October 3, 2018

SUBJECT: TRC COMMENTS FOR MUTTLEY SQUARE, PL2018-0017

A BINDING SITE PLAN

**GRADING AND DRAINAGE PLAN
AND DETAILS**

COVER SHEET AND
GENERAL NOTES

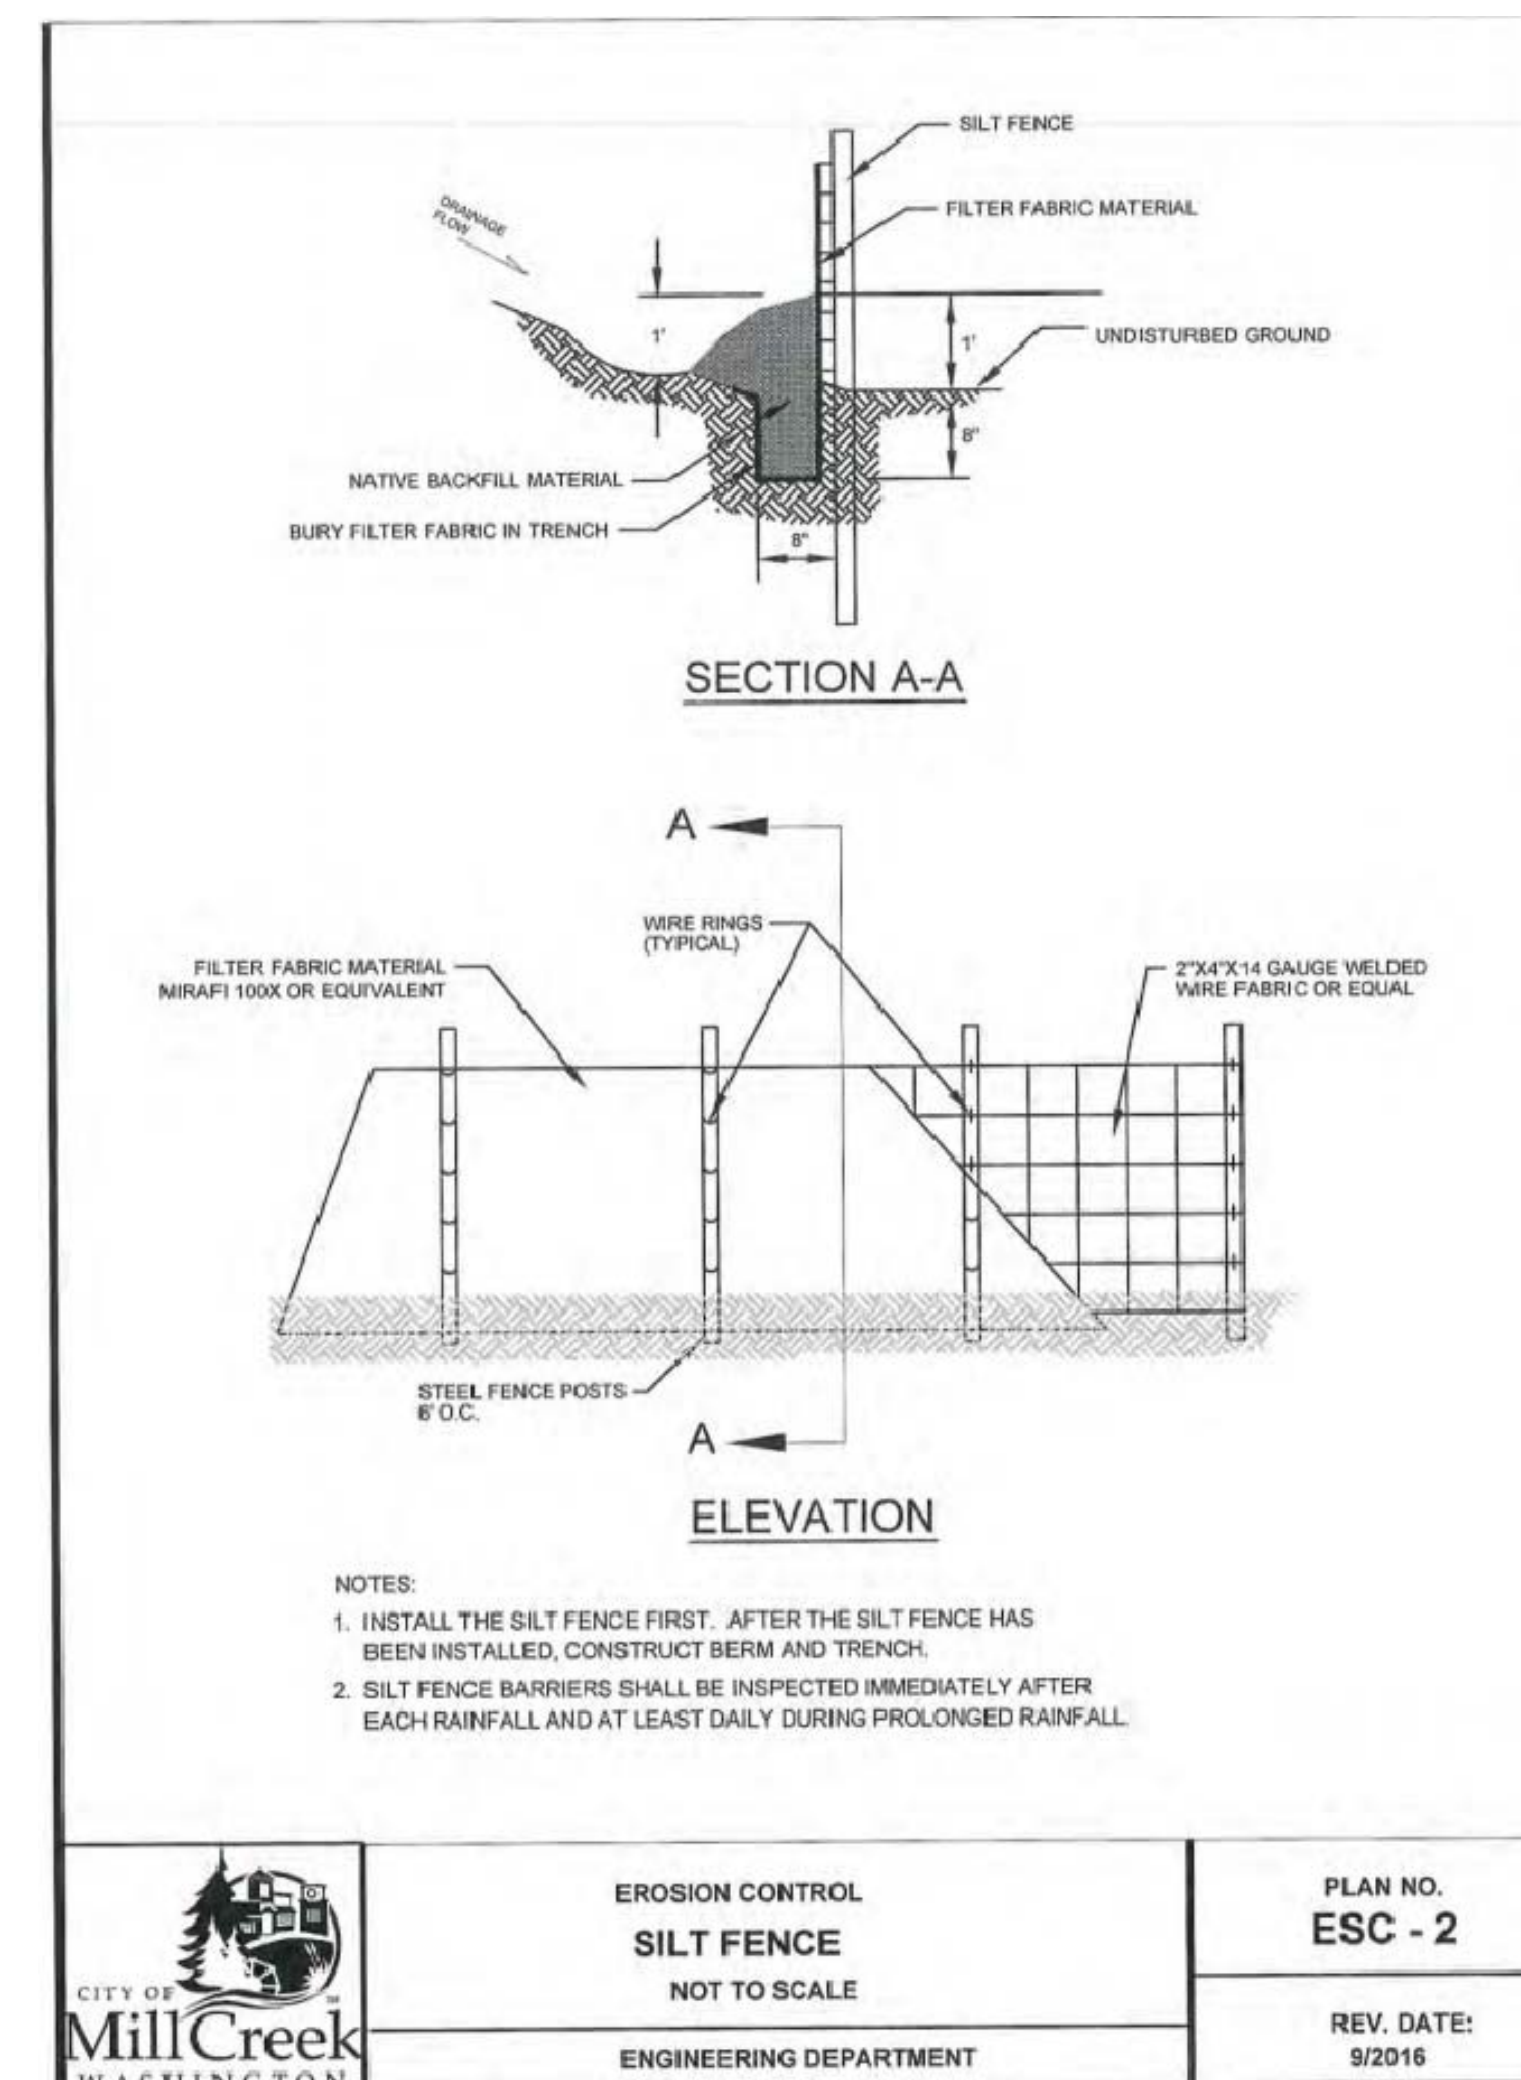
Sheet C1.1 (Cover Sheet and General Notes)

- Include Construction Sequence Notes on this sheet.

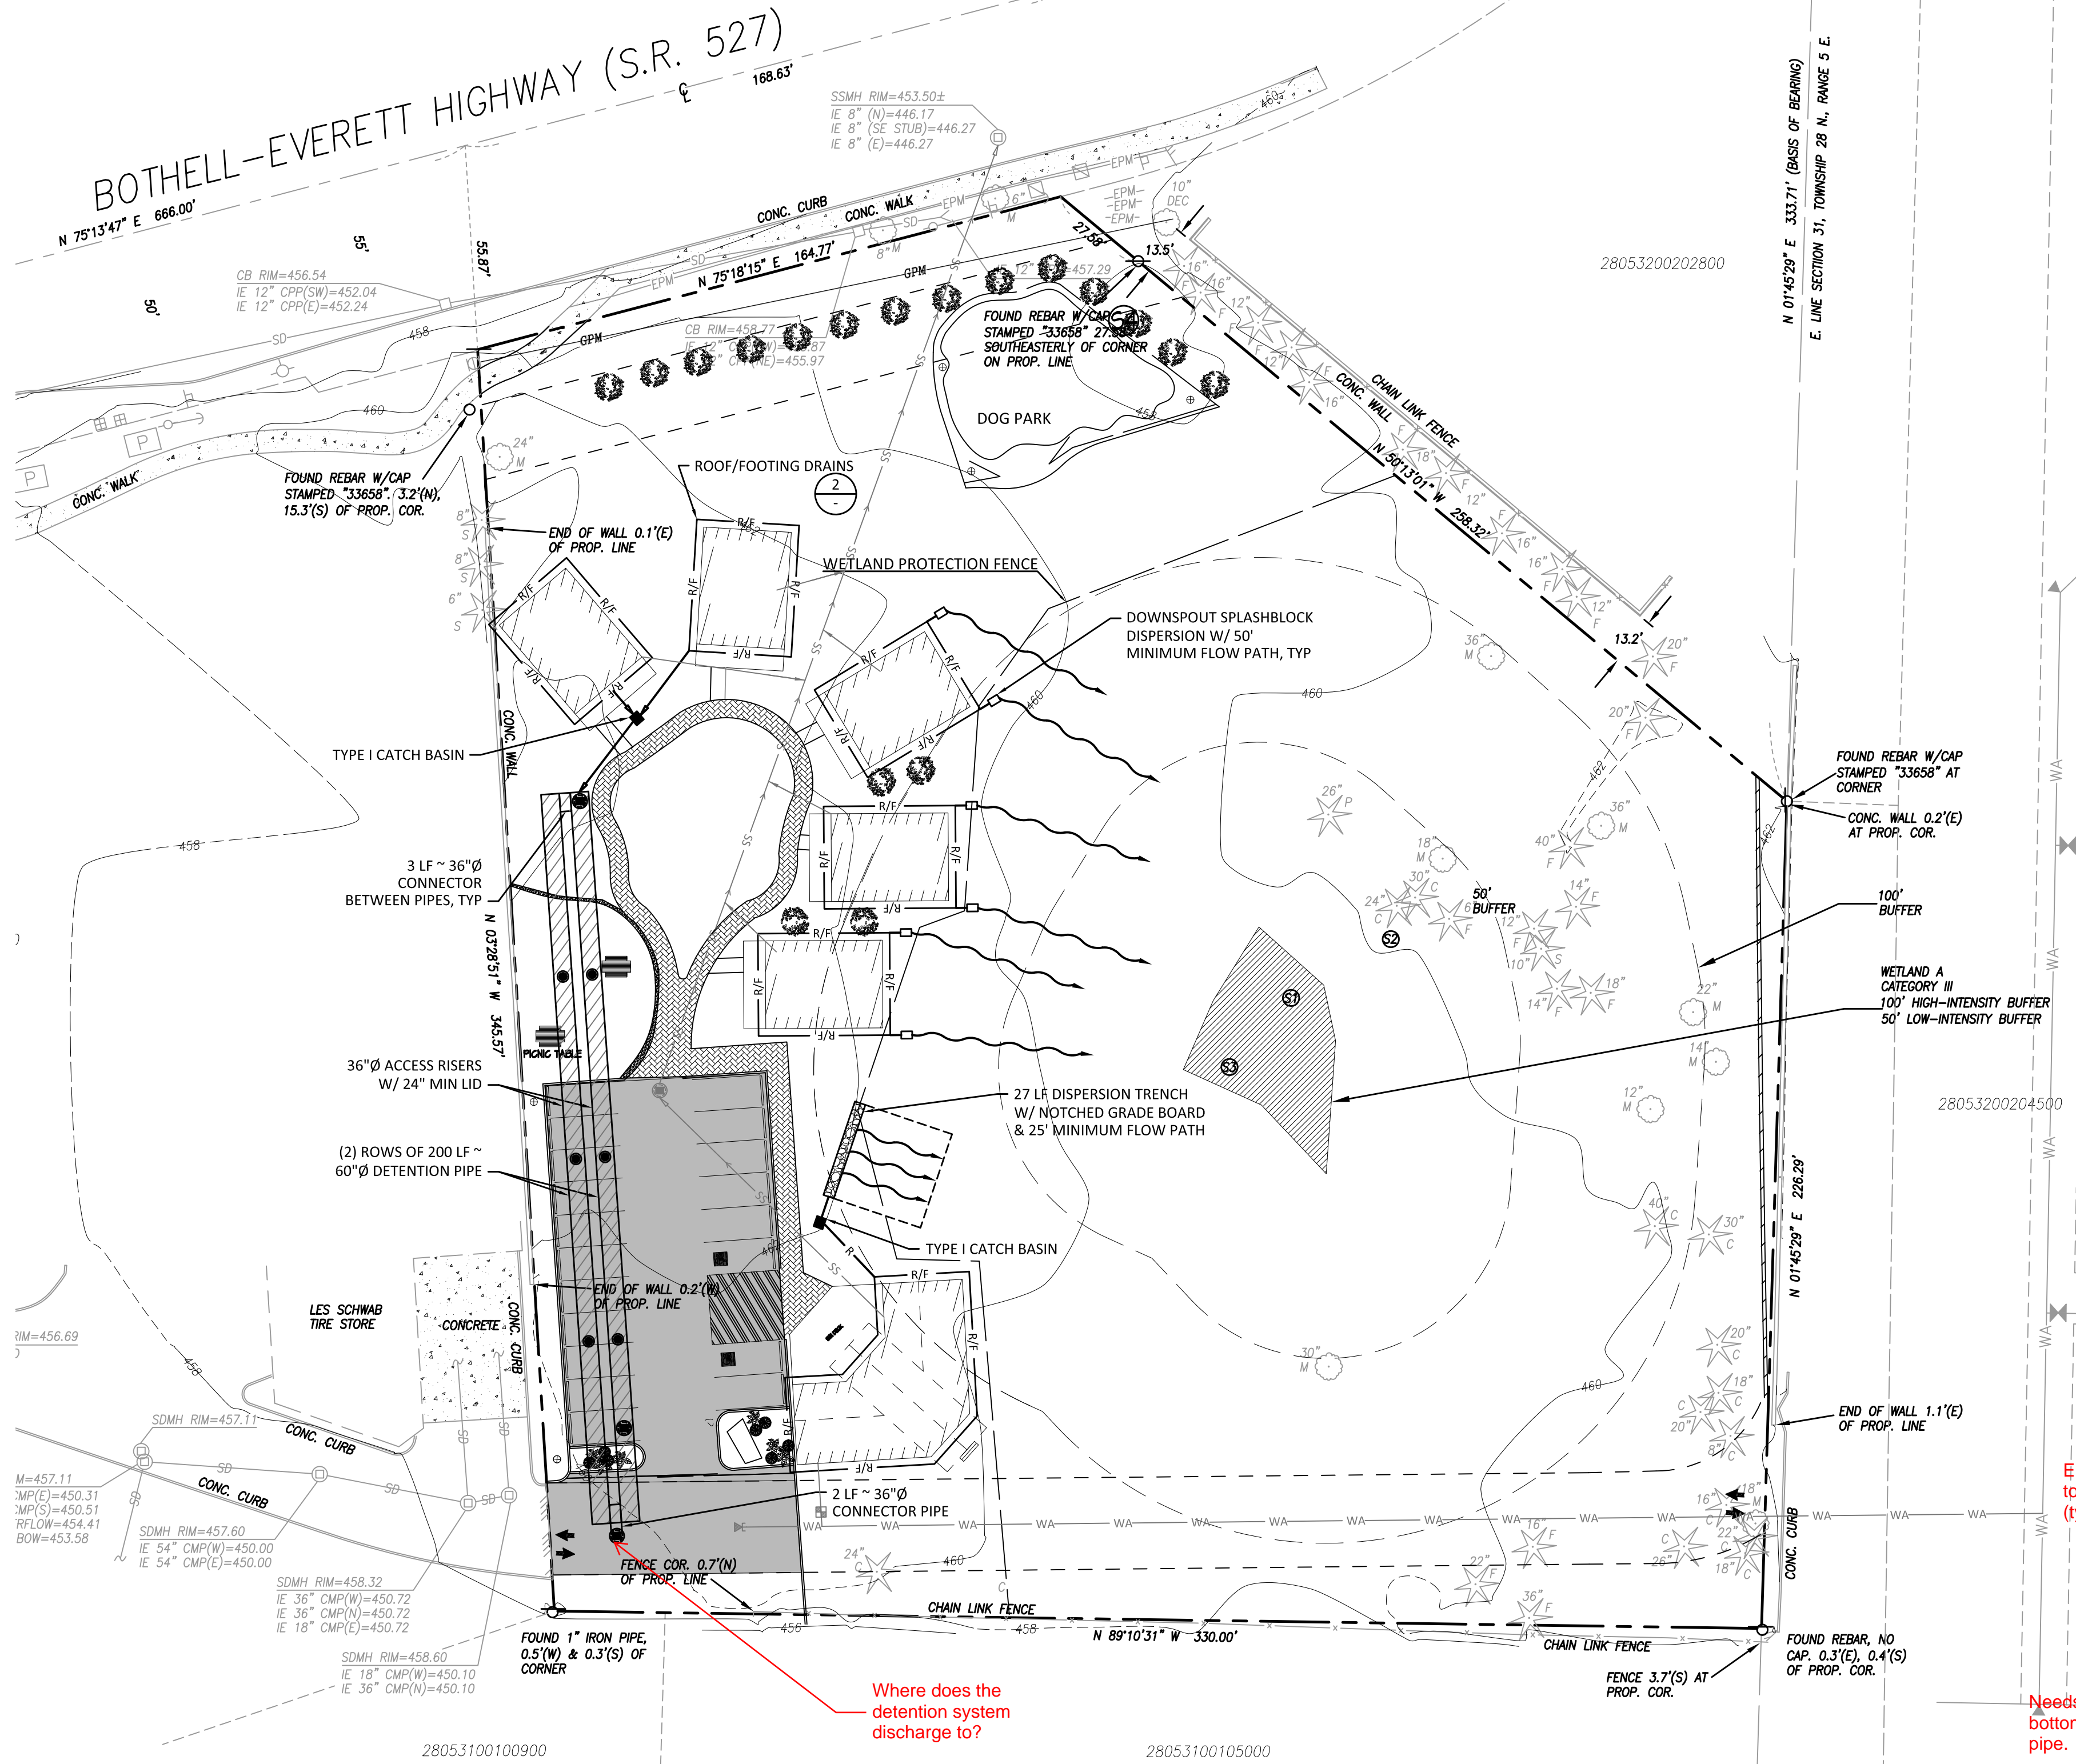
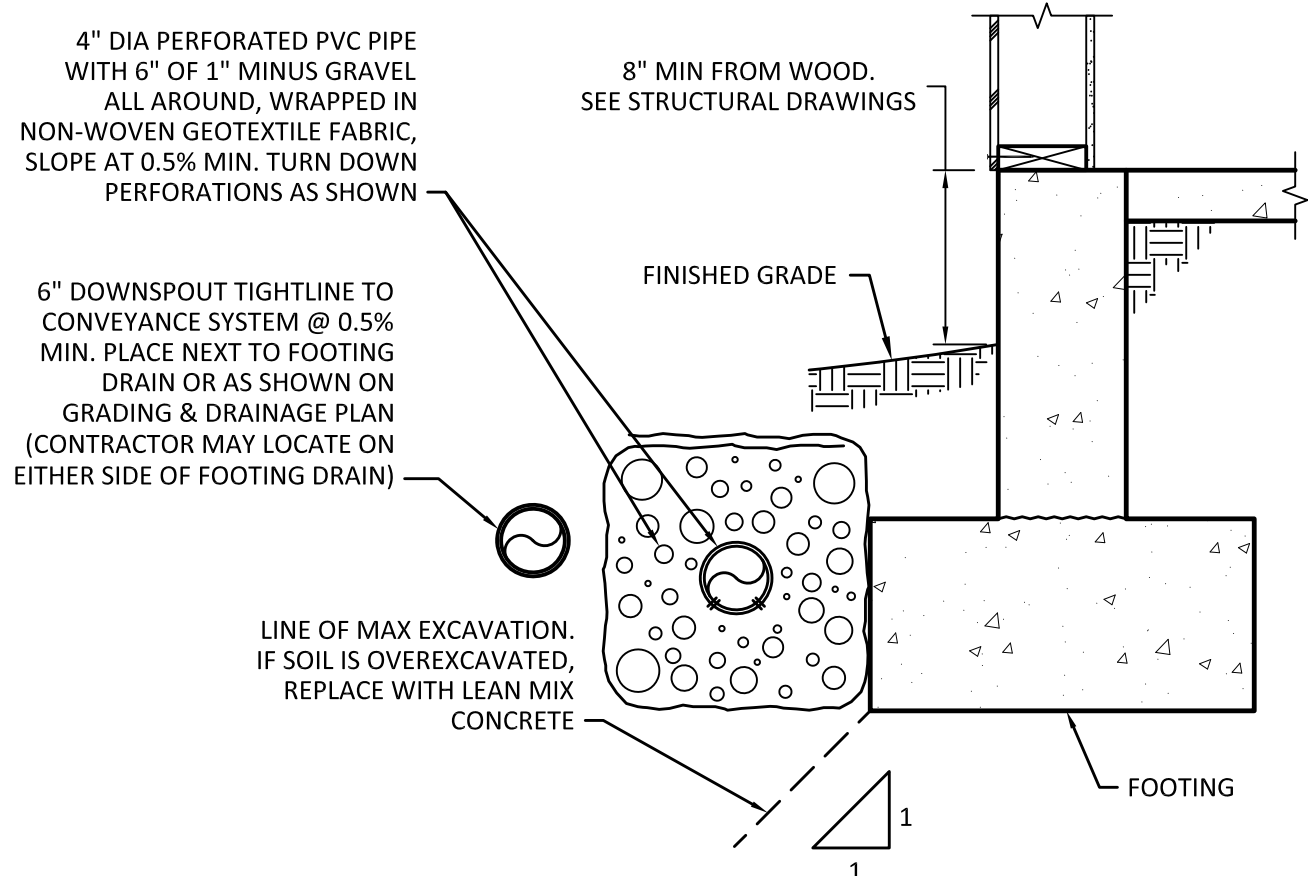
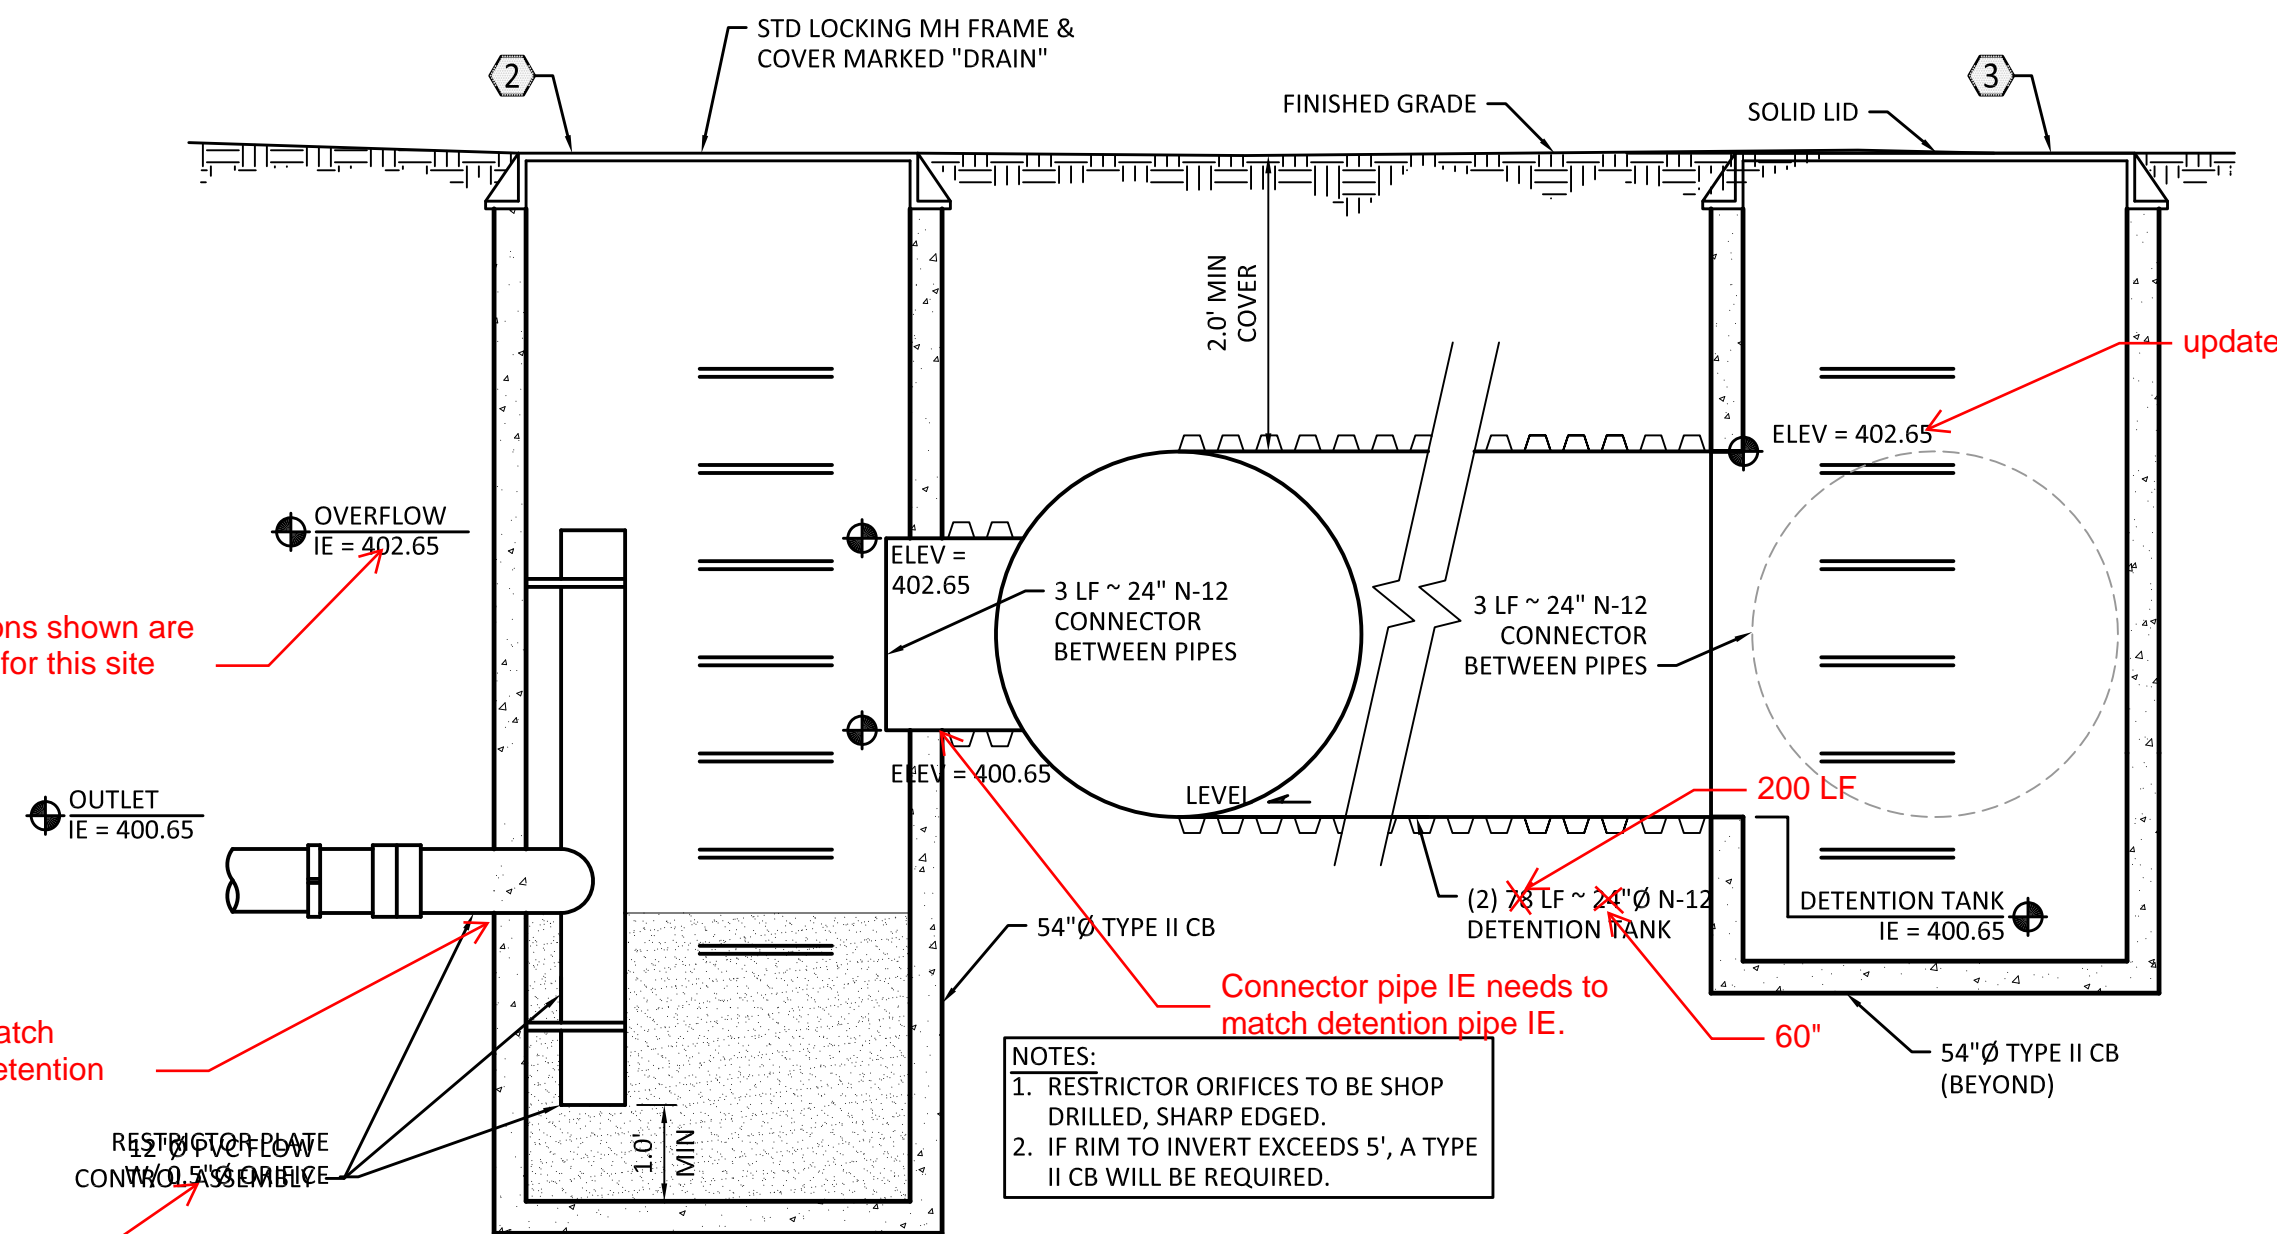
Sheet C3.1 (Grading and Drainage Plan and Details)

- Where does the detention system discharge to? It is not shown on the plans.
- How is water quality treatment being addressed? There is no BMP shown on the plans.
- How is runoff from the pervious areas being collected and conveyed to the detention tank?
- Elevations shown in the flow control structure with detention tank section are way too low for this site. Revise accordingly.
- The flow control structure outlet invert should be the same elevation as the bottom of the 60-inch detention system.
- The bottom of the 24-inch connector pipe needs to match the bottom of the 60-inch detention tank.
- Length of the 60-inch detention tank is 200 feet, not 78 feet. Revise accordingly.
